**Item 5.****Development Application: 44-48 O'Dea Avenue, Waterloo (Building A) - D/2018/789**

File No.: D/2018/789

<b>Date of Submission:</b>	12 July 2018  Amended plans 10 December 2018, 14 March 2019 and 1 April 2019
<b>Applicant:</b>	Crown W48 Pty Ltd
<b>Architect:</b>	Silvester Fuller
<b>Developer:</b>	Crown Developments Pty Ltd
<b>Owner:</b>	Crown W48 Pty Ltd and SP44338
<b>Cost of Works:</b>	\$26,962,451
<b>Zoning:</b>	The site is located in the B4 mixed use zone. The proposal is defined as a 'mixed use development' comprising 'retail premises' and 'residential accommodation', which are both permissible with consent.
<b>Proposal Summary:</b>	<p>The subject development application (DA) seeks consent for the construction of a mixed development ranging between two to six storeys in height, containing two retail tenancies, 37 residential apartments, three levels of basement parking and associated services. This building is referred to as building A.</p> <p>The development also includes the provision of access via a tunnel for the adjoining building to the east, building D. This tunnel will go under the future public domain, known as Lachlan Place. A development application for

**Figure 33:** Extract from the Sydney LEP 2012 Height of Building Map Sheet HOB\_017.

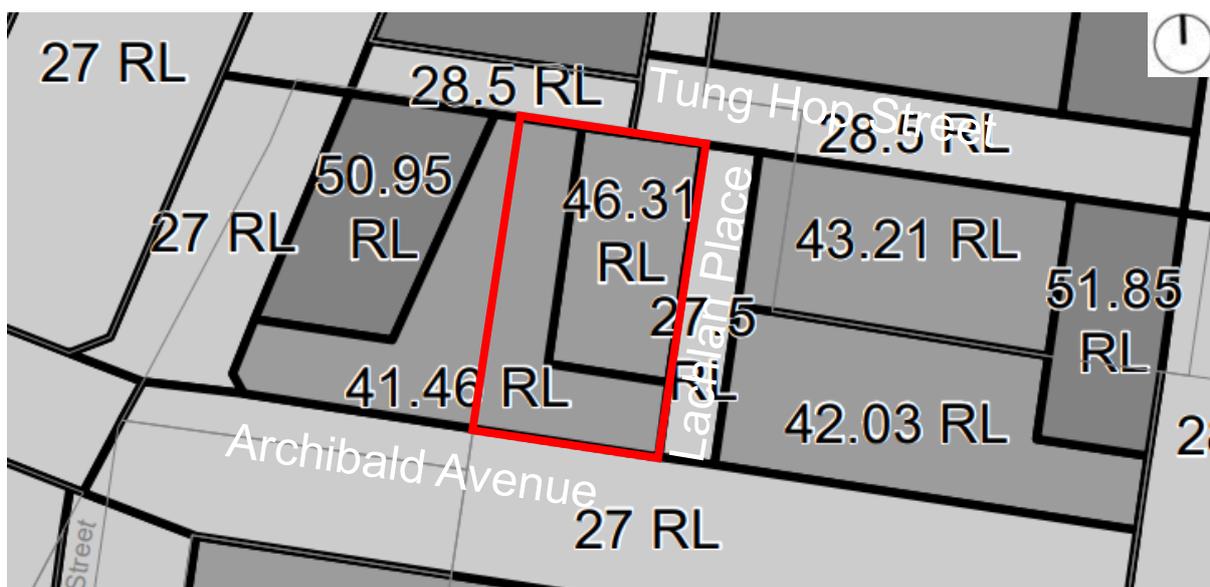
50. The site is subject to two separate maximum height of buildings controls in Reduced Levels (RLs) to the Australian Height Datum (AHD) under Clause 4.3 of the Sydney LEP 2012 as follows:
- RL 41.46 AHD.
  - RL 46.31 AHD.
51. An extract of the Sydney LEP 2012 height of buildings map sheet HOB\_017 is provided in the figure below, with the subject site outlined in red:

Figure 34: Extract of Level 4 floor plan highlighting areas of non-compliance in red.

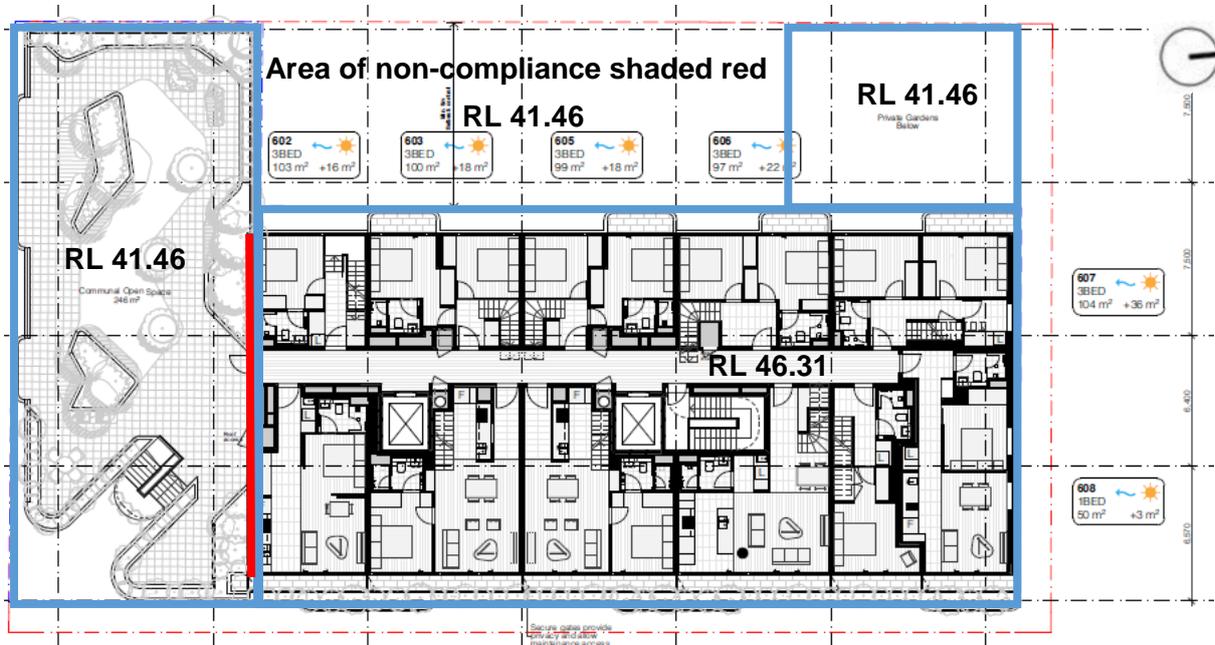
52. The building is designed as a part two, part four story building, with a taller five and six storey component fronting Lachlan Place. The five and six storey component of the building has a proposed maximum height of RL 46.3 AHD. While this is 0.01 metres below the maximum height of RL 46.31 AHD prescribed by the Sydney LEP 2012, this taller component of the building extends laterally to the south into the zone of the lower height control of RL 41.46 AHD. The floor plan of level 4 and east elevation are shown in the figures below which highlight the area of non-compliance in red:

53. To the south (towards Archibald Avenue), the floor plate, architectural detailing and southern wall of the taller part of the building extends within RL 41.46 AHD zone by approximately 0.65 metres in depth. This component of the building breaches the maximum RL 41.64 AHD height of buildings development standard by 4.84 metres or 11.7%.
54. A written request has been submitted to Council in accordance with Clause 4.6(3)(a) and (b) of the Sydney LEP 2012 seeking to justify the contravention of the height development standard by demonstrating:
- (a) That compliance with the development standard is unreasonable or unnecessary in the circumstances of the case.
  - (b) That there are sufficient environmental planning grounds to justify contravening the standard.
55. A copy of the applicant's written request is provided at Attachment D.

62. Council officers agree with the justification provided in the written request. It demonstrates that the building components which breach the height standard result in an appropriate definition to the surrounding street network and minimal visual impact from the additional massing viewed from the public domain.
63. The applicant's justification that the components of the building subject to the non-compliance do not result in adverse environmental planning impacts by way of urban design, view loss or overshadowing are supported.
64. Given the above, Council officers are satisfied that the applicant has adequately demonstrated that there are sufficient environmental planning grounds to vary the development standard.

**Figure 36:** Extract from Sheet 017 of the Sydney DCP 2012 Height in storeys map.

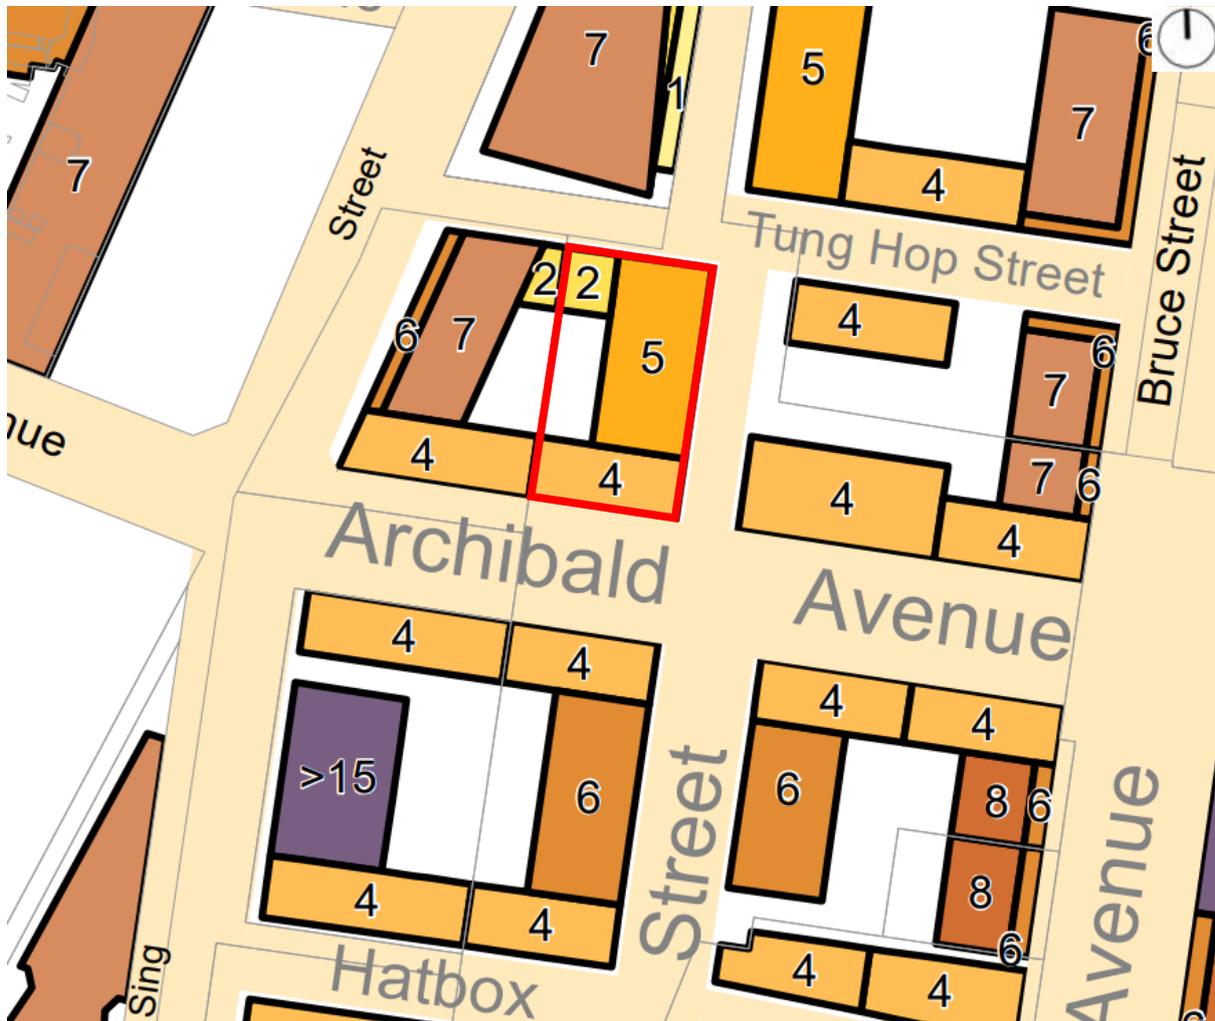
- (c) Under the Sydney DCP 2012, the height in storeys provisions for the site and immediate surrounding area in the Lachlan Precinct generally require two to four storeys with a higher component of between five to eight storeys as shown in the figure below. The proposed development complies with the strategic intent of these provisions.

**Figure 37:** Extract from North-South Section drawing with non-compliance boxed in red.

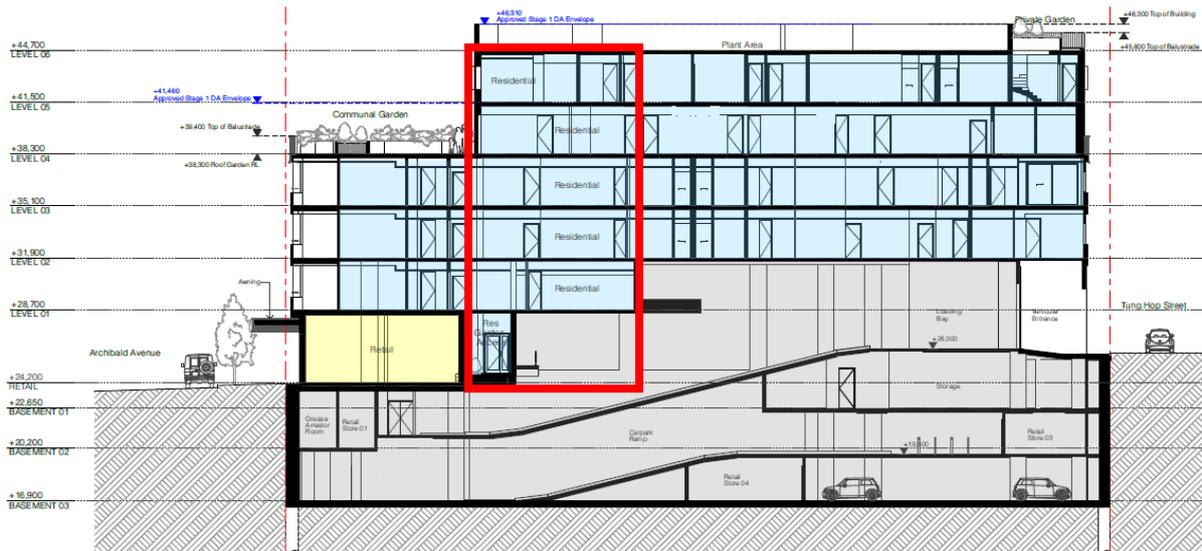
80. The development, as proposed, does not strictly comply with the building height in storeys.
81. The site is subject to three separate height in storey controls. Figure 36 above illustrates the height in storeys for the subject site required by the Sydney DCP 2012.

82. The proposed development generally conforms to these requirements, including:
  - (a) Four storeys fronting Archibald Avenue.
  - (b) Five storeys fronting Lachlan Place (subject to an appropriate design modification requiring the deletion of the windows to the void above the retail premises fronting Lachlan Place and raising the awning level as discussed under the heading **Awning Height** below).

- (c) Two storeys to Tung Hop Street.
83. Despite this, the development technically provide for six storeys for part of the site and this component extends into the area designated for a four storey height by 650mm, as indicated in the section drawing extract in the figure below, boxed in red and discussed above in relation to Clause 4.3 and 4.6 of the Sydney LEP 2012.

Figure 38: Proposed east elevation extract showing non-compliance with awning height

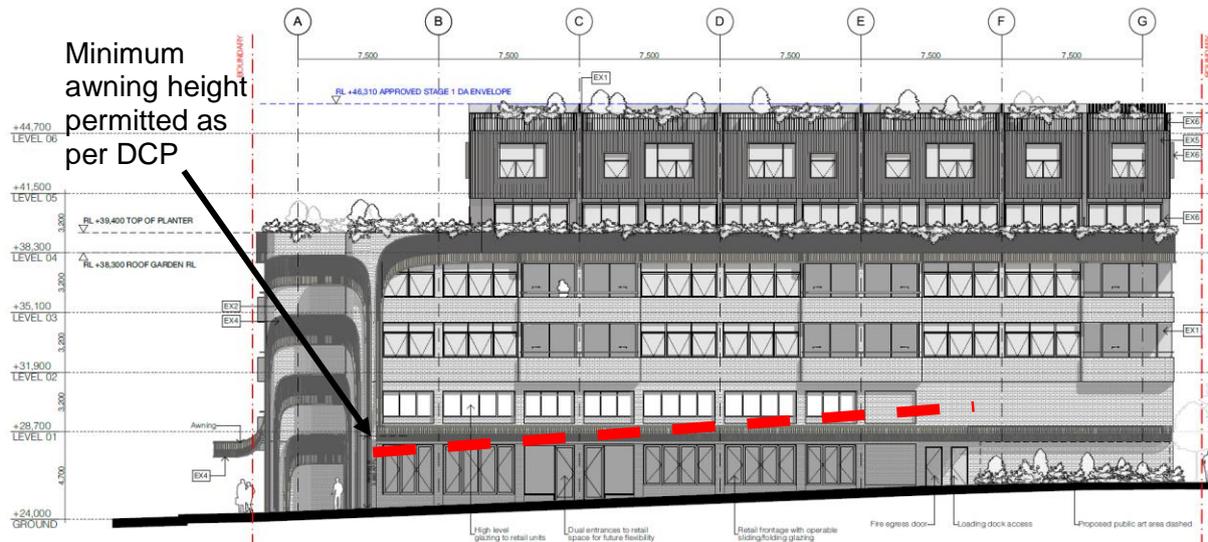
87. The proposed awning does not fully comply with the requirements of Section 3.2.4(4) of Sydney DCP 2012 in that it does not provide at least 3.2 metres clearance above the footpath to the south eastern section fronting Archibald Avenue and to the north-eastern section fronting Lachlan Place. This is shown in the figures below.

- 88. At the lowest point to Archibald Avenue, the awning will be approximately 3.125 metres above the height of the footpath. At the lowest point to Lachlan Place, the awning will be approximately 2.312 metres above the height of the footpath. The height of these awnings also exceeds the maximum 4.2 metres in some locations.
- 89. The non-compliance is not supported in this instance, as the clearance above the public domain is provides insufficient pedestrian amenity and the awning has not been stepped appropriately with the gradient of the surrounding streets, in accordance with Section 3.2.4(13) of the Sydney DCP 2012.

90. Accordingly, appropriate deferred commencement conditions requiring design modifications to ensure compliance have been recommended to be imposed.

Figure 39: Proposed south elevation extract showing non-compliance with awning height

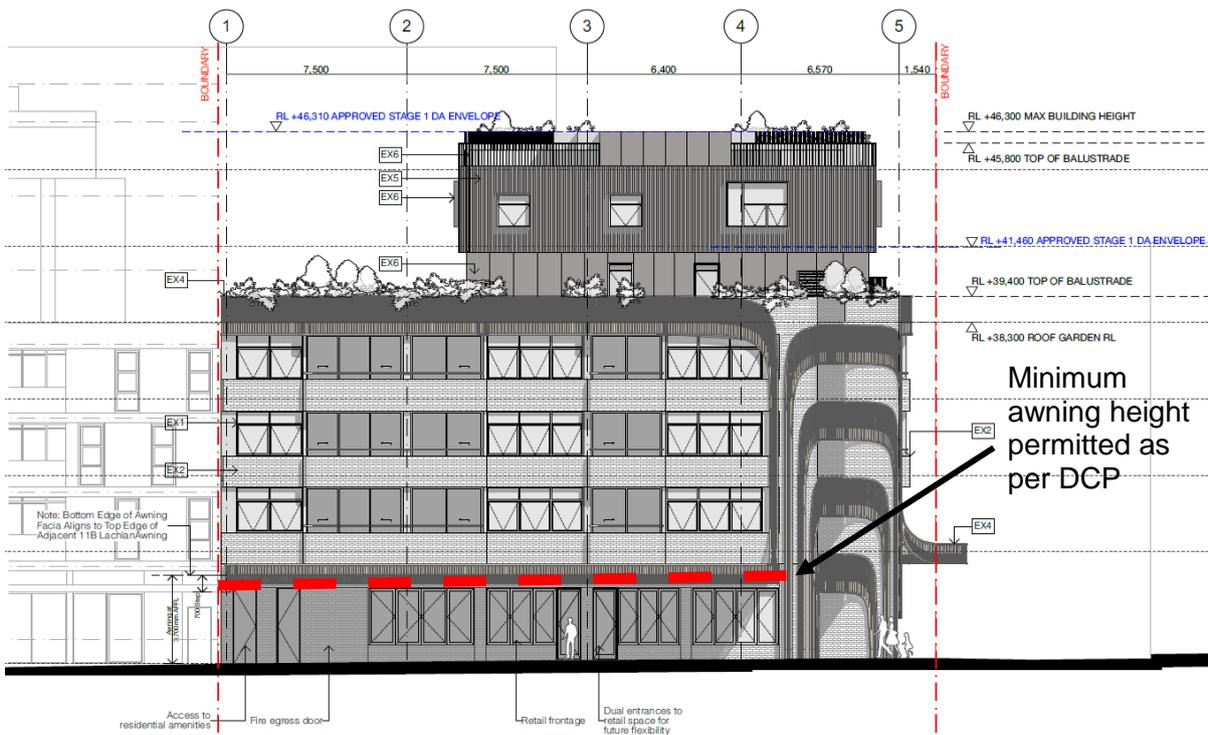
- (c) The height of the awning does not match at the corner of Archibald Avenue and Lachlan Place. The awning needs to be lower on Lachlan Place to provide better weather protection for pedestrians.
